SSDA REPORT

North Sydney Public School 182 Pacific Highway, North Sydney NSW 2060

Report Prepared for: Department of Education
Report Prepared by: Lucy Alderson
Our Ref: AN021-216878 SINSW
Date: 27 August 2021

1 ELEVATION
BUILDING J - SOUTH ELEVATION
SCALE: 1:100

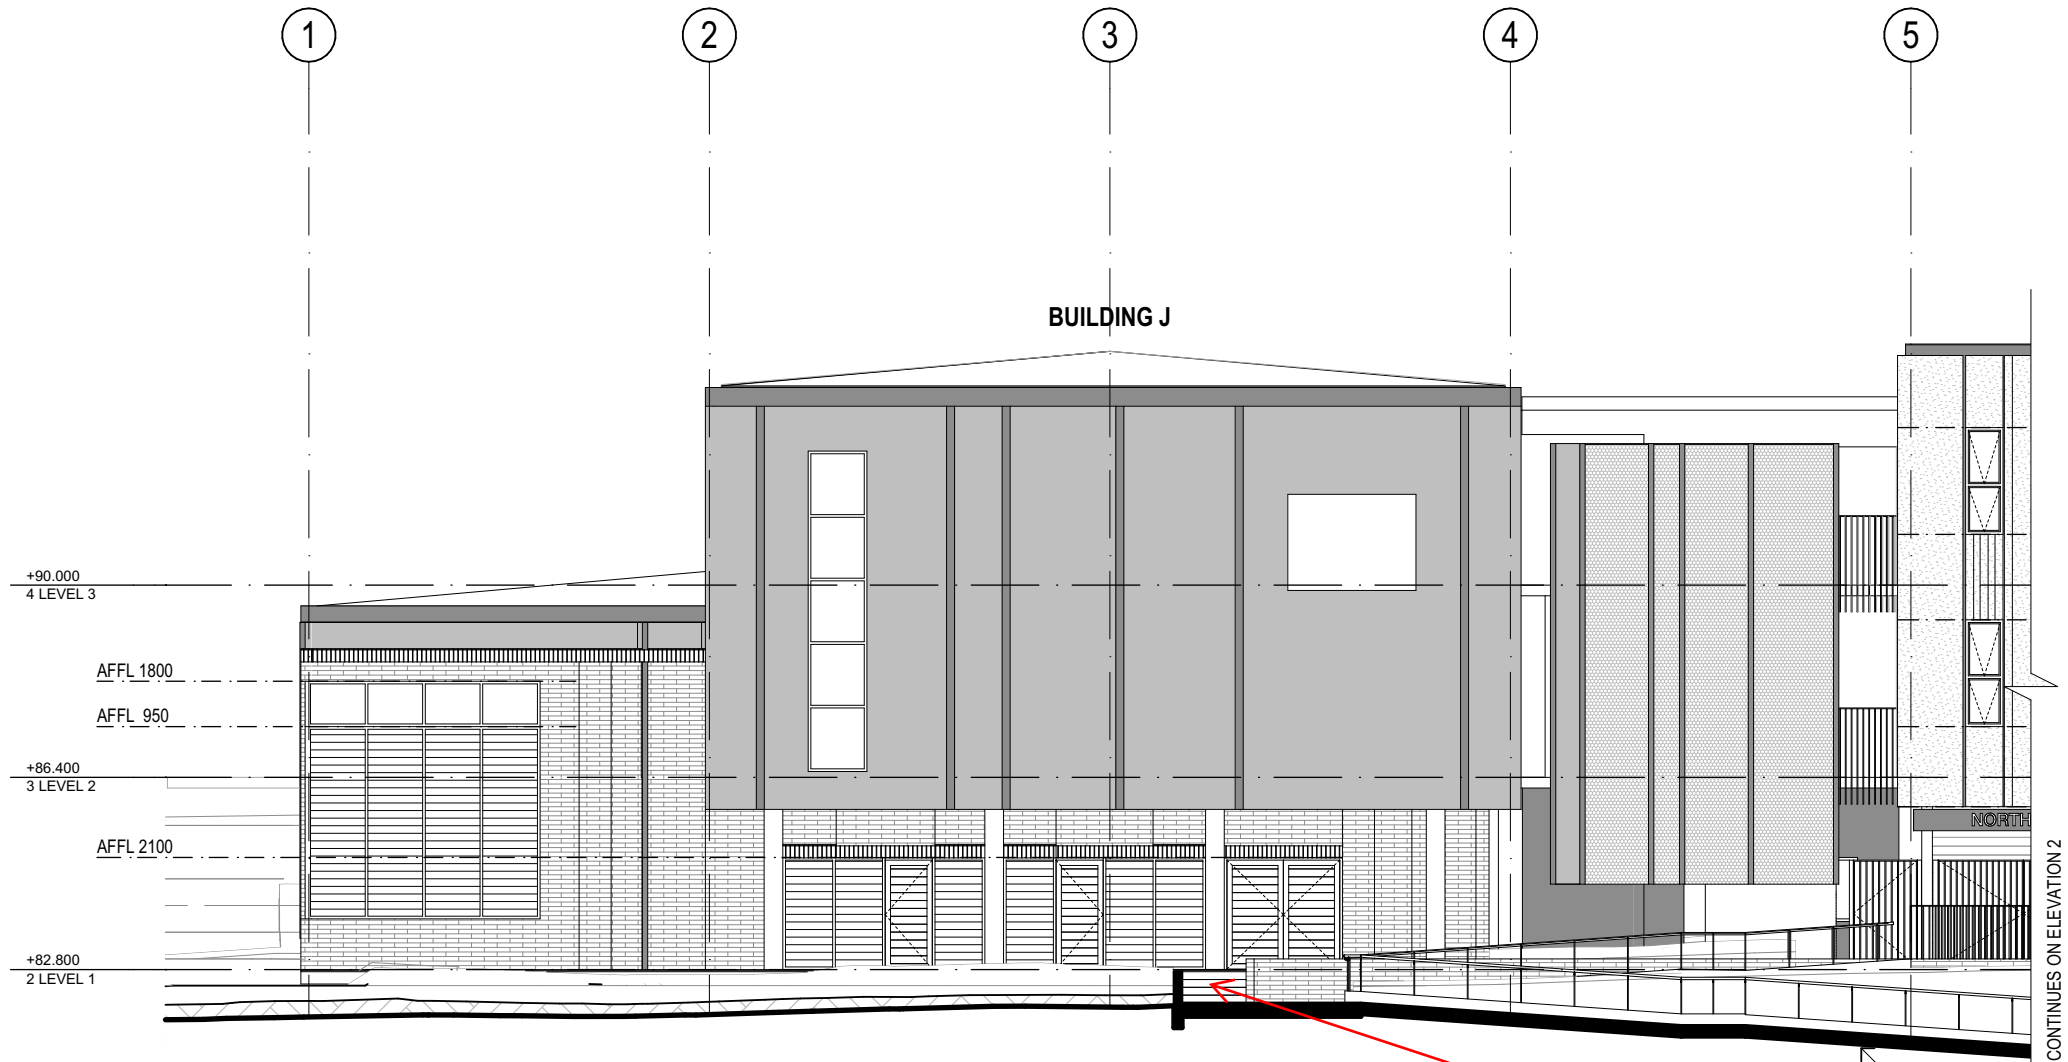
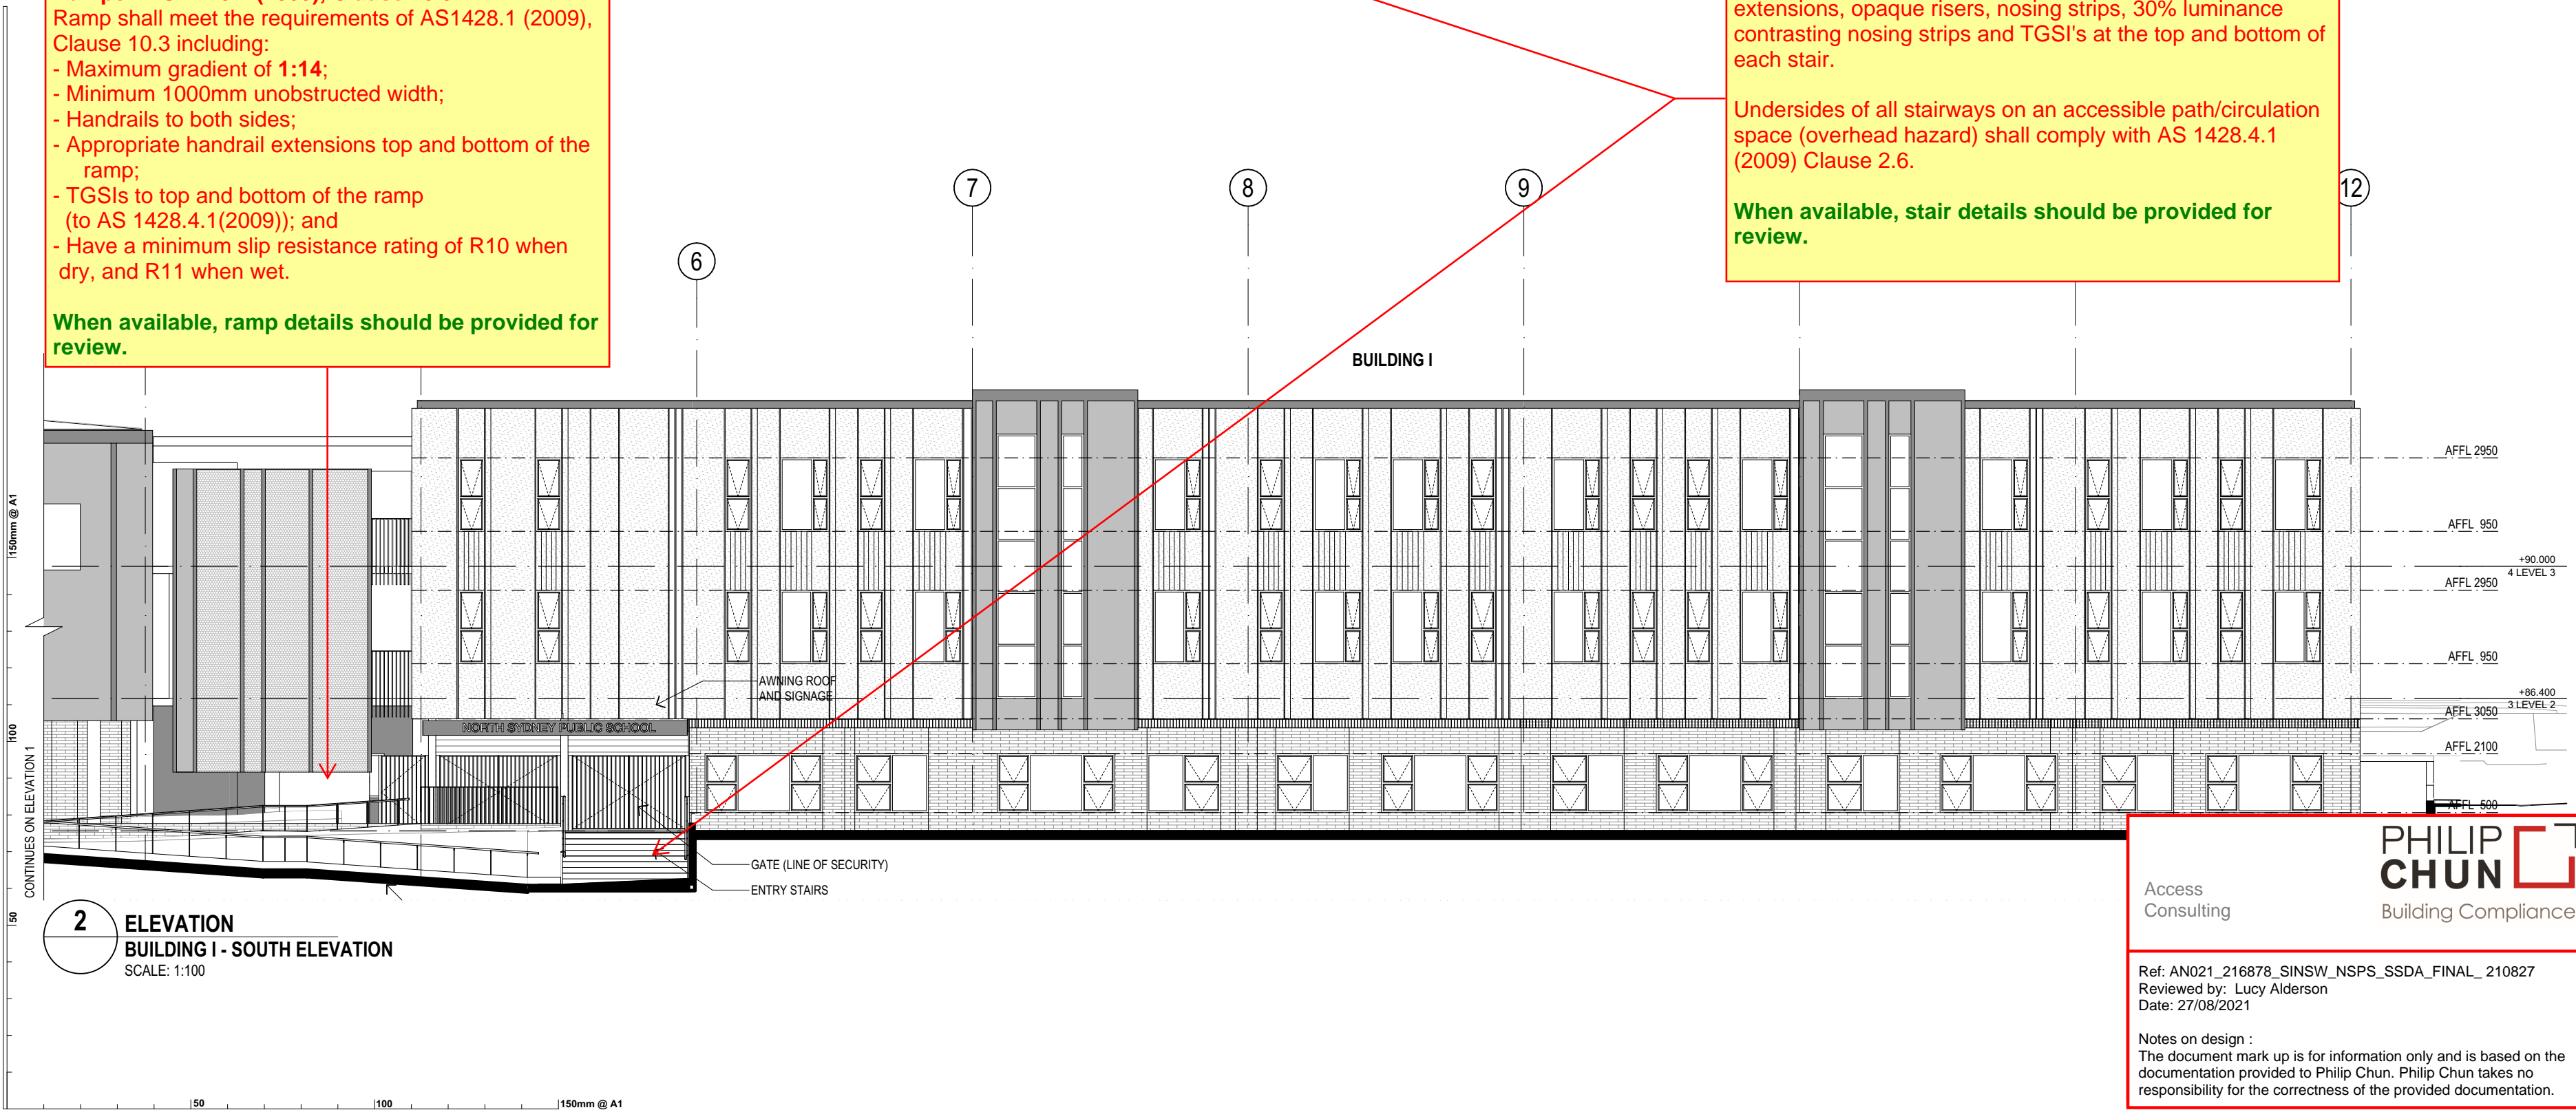
Ramps - AS 1428.1 (2009), Clause 10.3
Ramp shall meet the requirements of AS1428.1 (2009), Clause 10.3 including:

- Maximum gradient of **1:14**;
- Minimum 1000mm unobstructed width;
- Handrails to both sides;
- Appropriate handrail extensions top and bottom of the ramp;
- TGSIs to top and bottom of the ramp (to AS 1428.4.1(2009)); and
- Have a minimum slip resistance rating of R10 when dry, and R11 when wet.

When available, ramp details should be provided for review.

NOTE: Handrails - BCA, Part D2.17 9a) (iii)
In a class 9b building used as a primary school -
(A) have one handrail fixed at a height of not less than 865mm; and
(B) have a second handrail fixed at a height between 665mm and 750mm, measured above nosings of stair treads and the floor surface of the ramp, landing or the like

When available, stair details should be provided for review.

1
ELEVATION
BUILDING J - NORTH ELEVATION
SCALE: 1:100

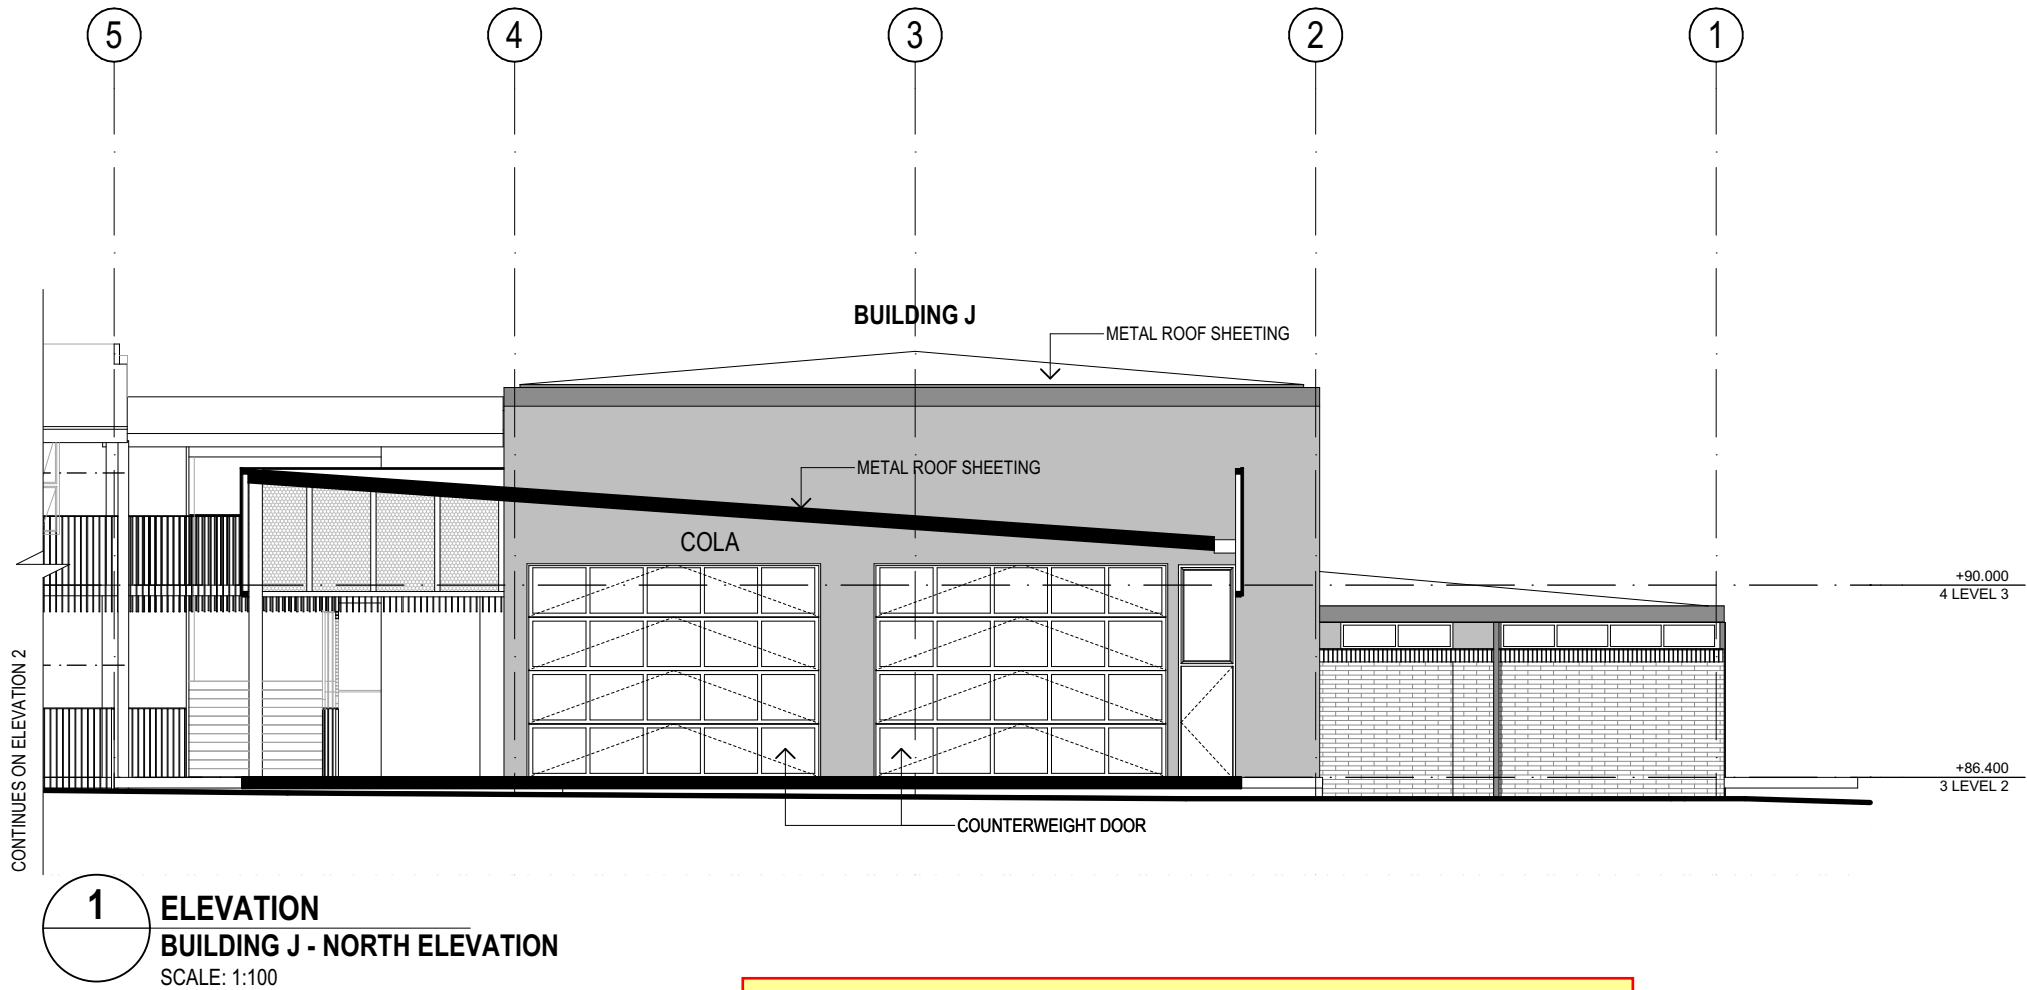
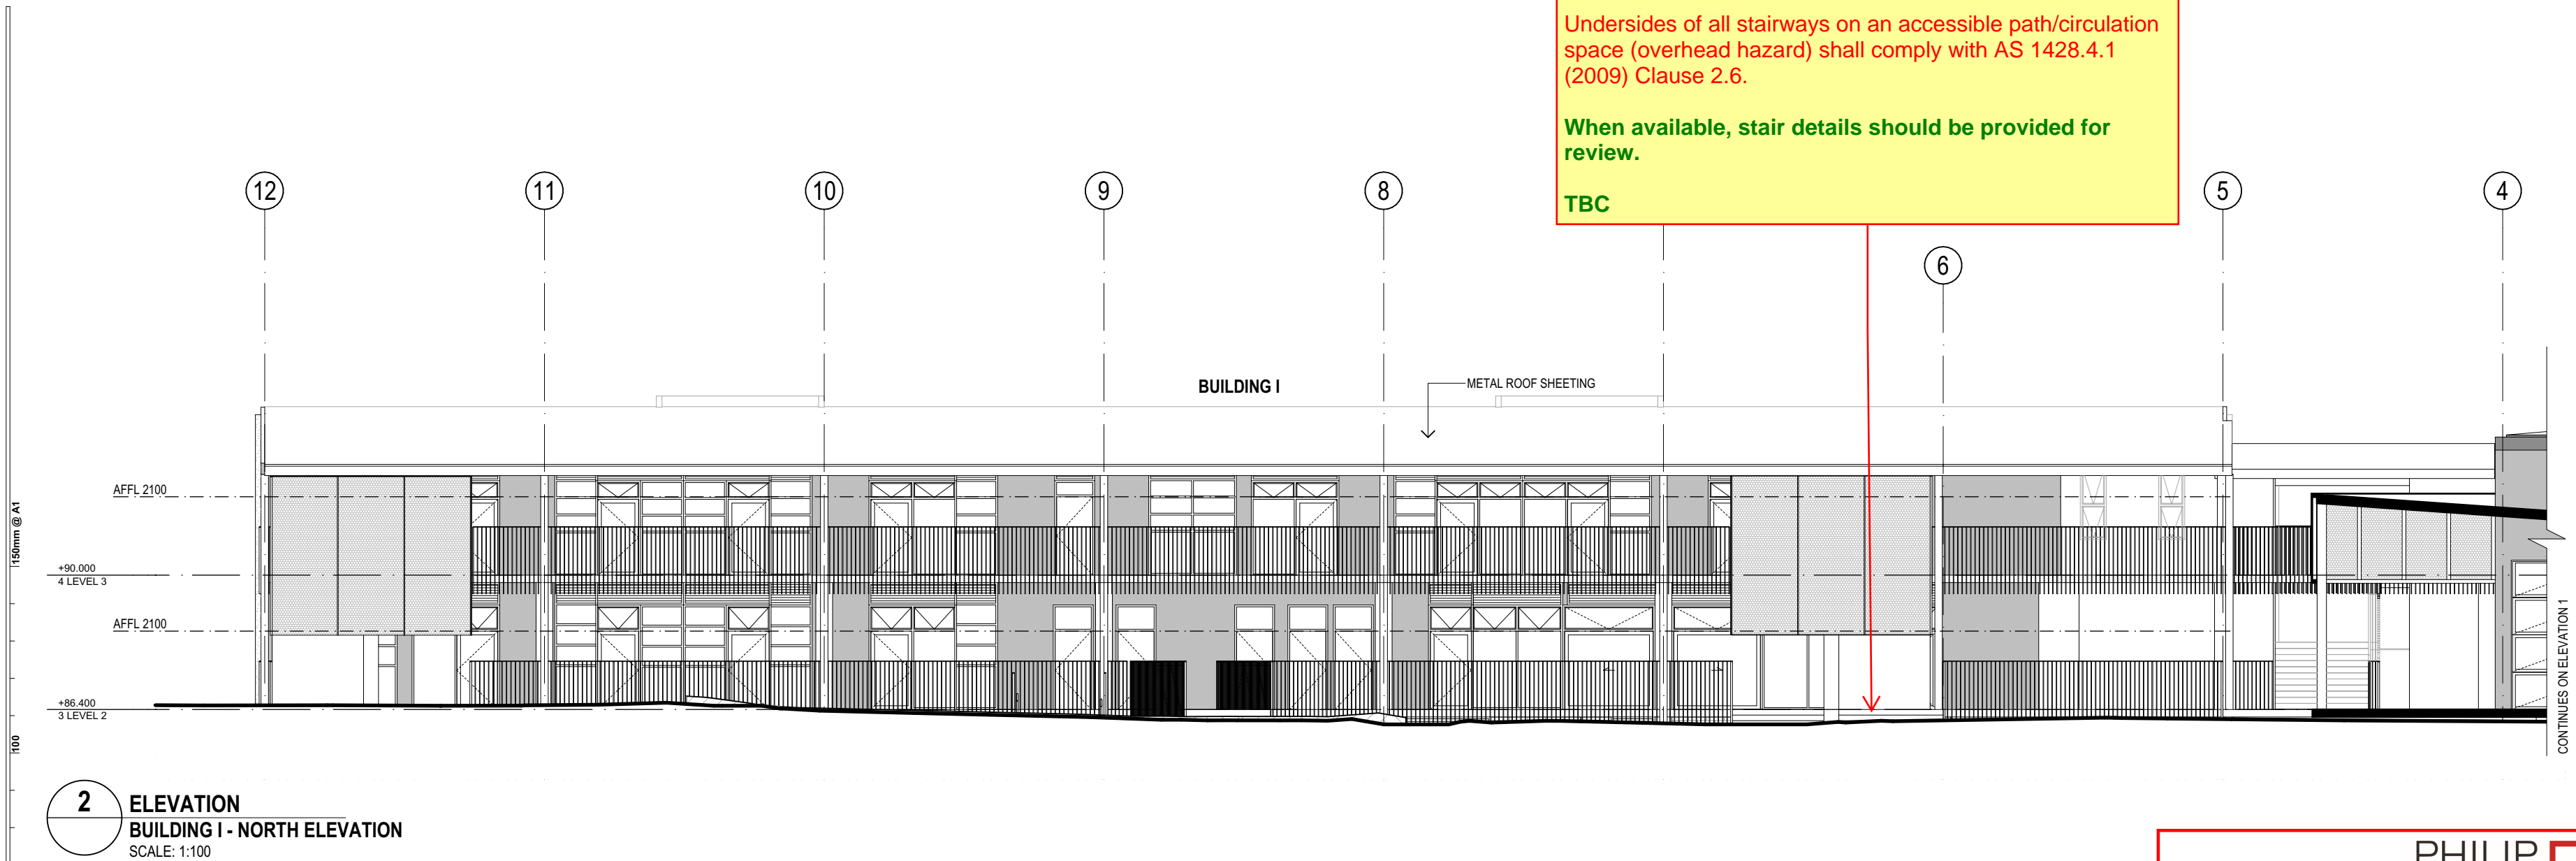
Stairways - AS 1428.1 (2009), Clause 11
Designers to ensure stair details meet the requirements of AS1428.1 (2009), Clause 11, including handrails, handrail extensions, opaque risers, nosing strips, 30% luminance contrasting nosing strips and TGSi's at the top and bottom of each stair.

Undersides of all stairways on an accessible path/circulation space (overhead hazard) shall comply with AS 1428.4.1 (2009) Clause 2.6.

When available, stair details should be provided for review.
